PLANNING AND ZONING CASE CHECKLIST

Project Number SP2019-037
Project Name Ridge Road Retail Center
Type SITE PLAN
Subtype
Status P&Z HEARING

| Type of Review / Notes | Contact | Sent | Due | Received | Elapsed Status | Remarks |
|--|---------|------|-----|----------|----------------|---------|
| SP2019-037; Site Plan for Ridge Road Retail Center (PD-32) | | | | | | |

| Type of Review / Notes | Contact | Sent | Due | Received | Elapsed Status | Remarks |
|--|---------|------|-----|----------|----------------|---------|
| SP2019-037; Revised Submittal-- Site Plan for Ridge Road Retail Center(PD-32) | | | | | | |

1 TREESCAPE PLAN
1"=20'-0"

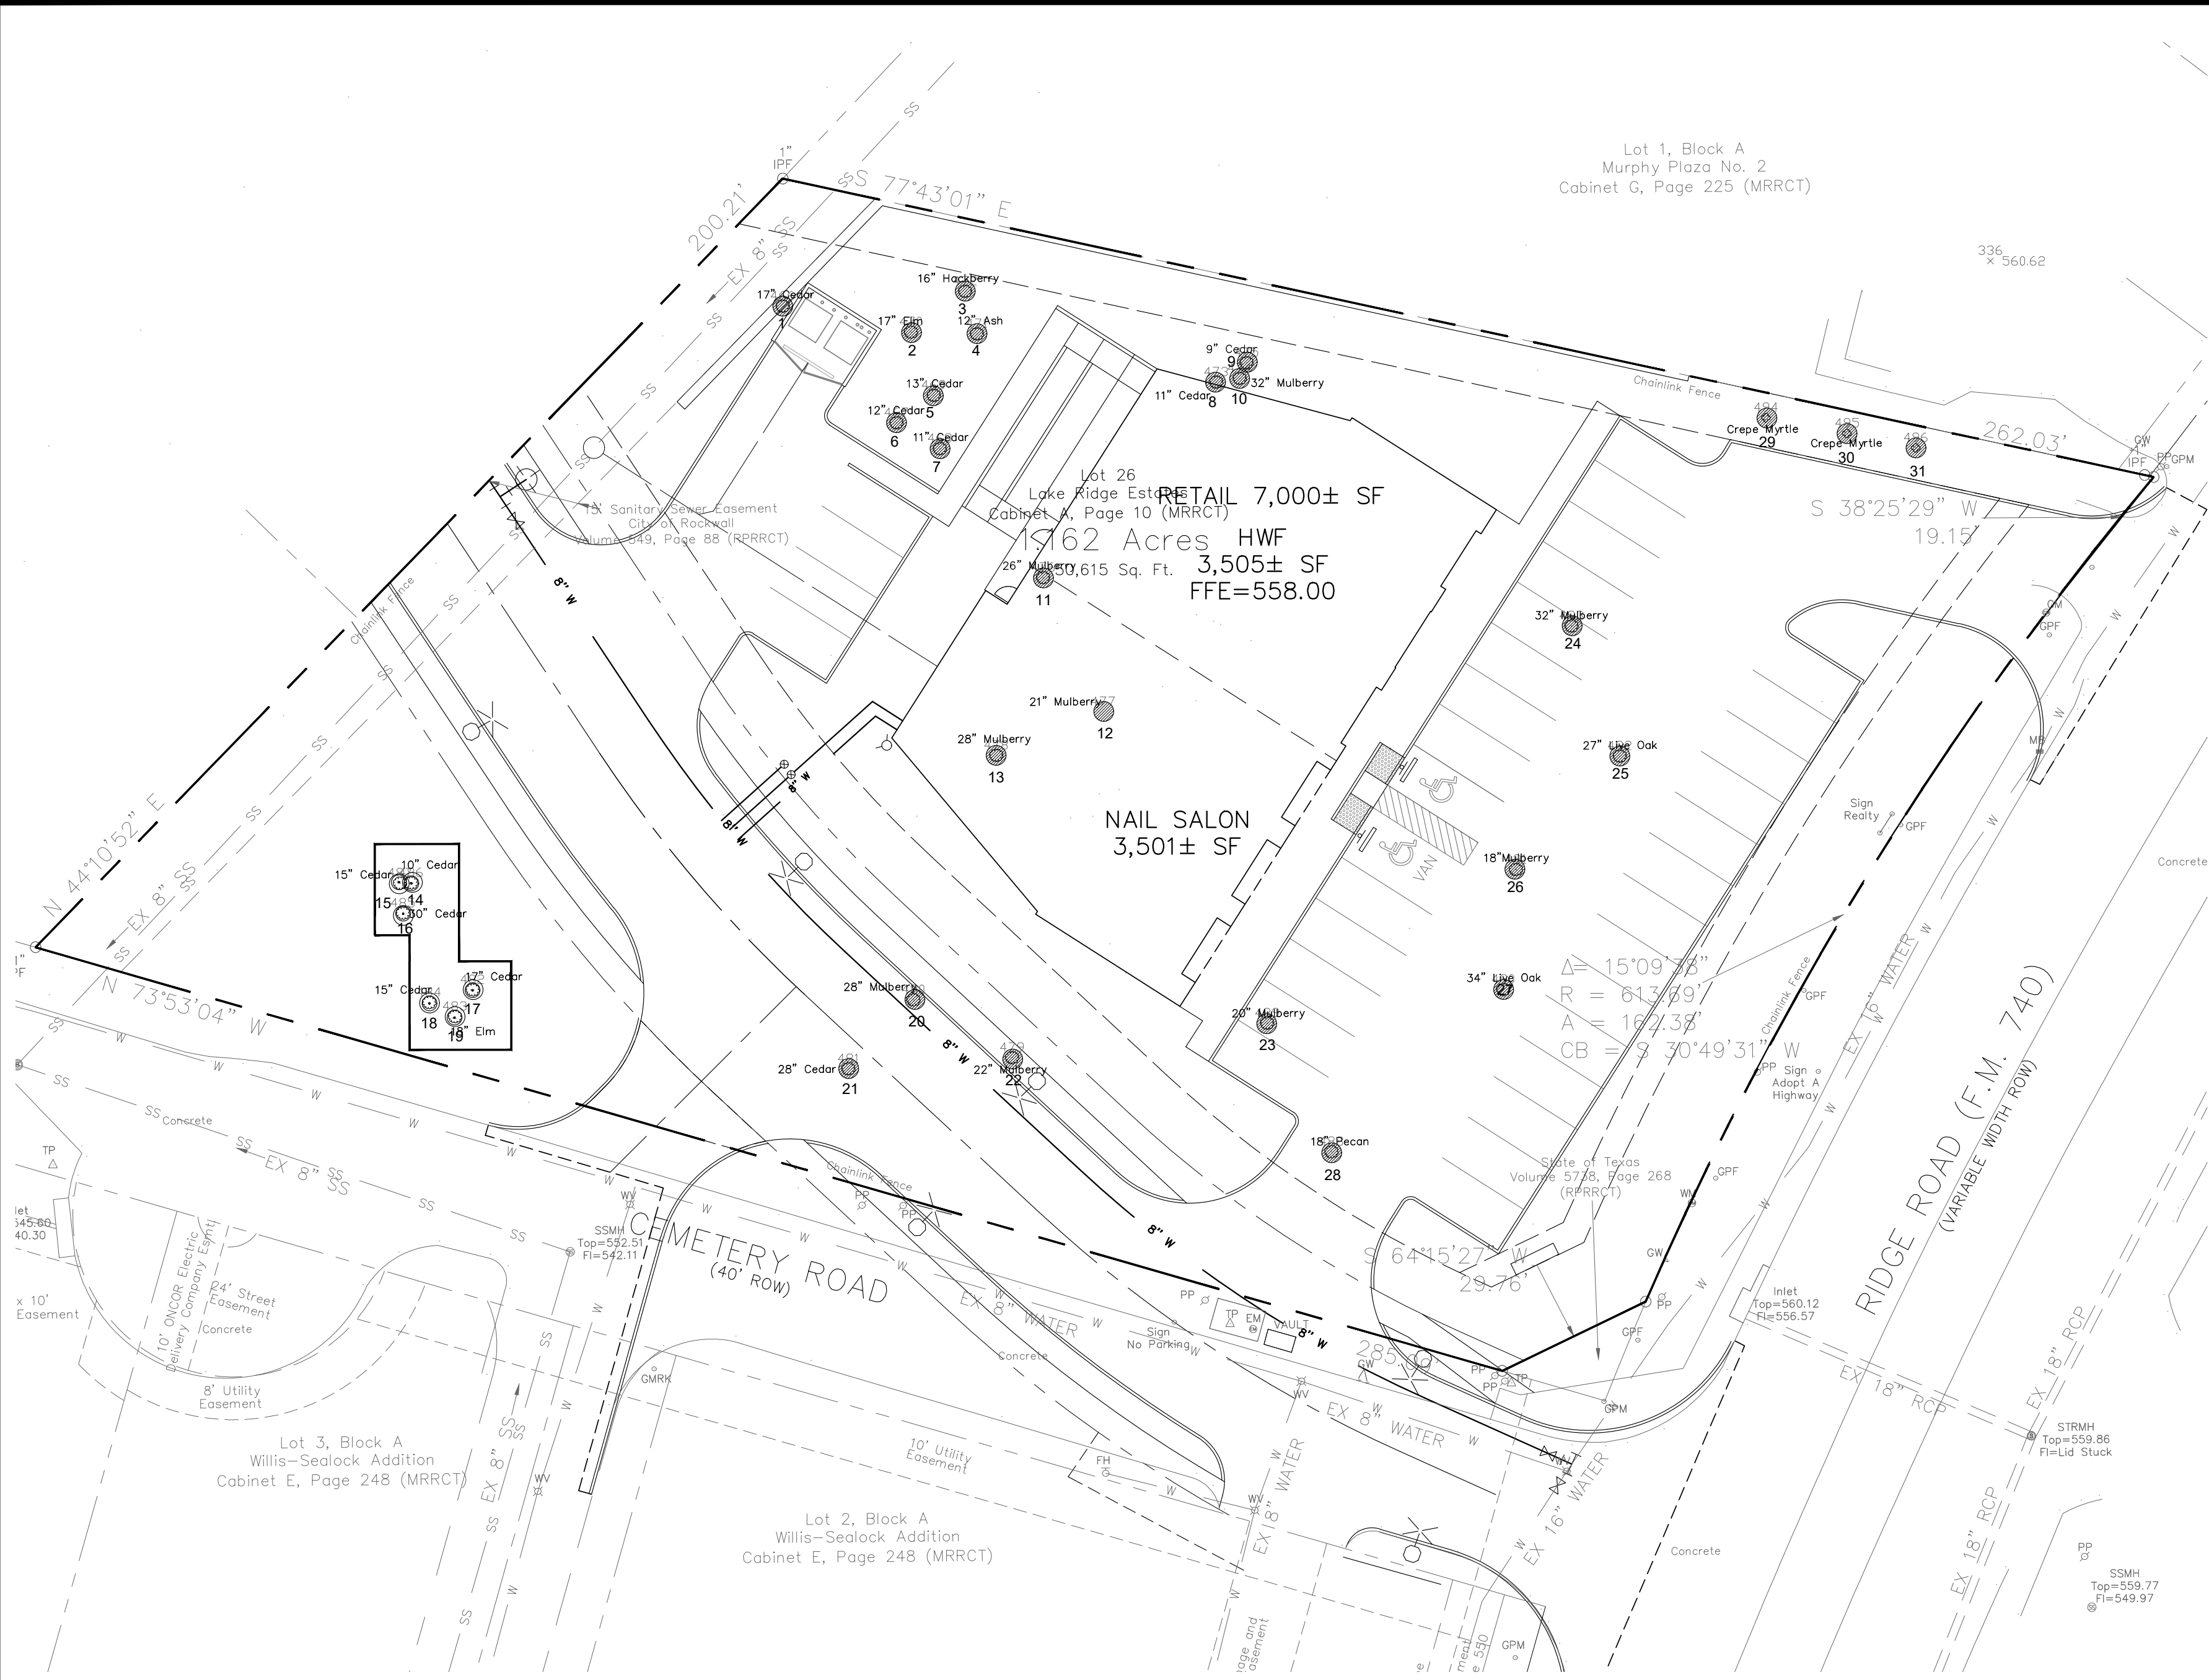
| Type of Review / Notes | Contact | Sent | Due | Received | Elapsed Status | Remarks |
|--|----------------|------------|------------|-----------|----------------|------------------------|
| M.12 Treescape Plan. According to Section 3.4, Treescape Plan Review Process, of Article IX, of the UDC, The planning and zoning commission will review and approve or disapprove the treescape plan. The decision of the planning and zoning commission may be appealed to the city council. The treescape plan requires approval by the Planning and Zoning Commission as submitted. (1) Total mitigation due= 336 caliper inches. Refer to Article IX, Sec. 5, Tree Mitigation Requirements in order to satisfy mitigation balance | | | | | | |
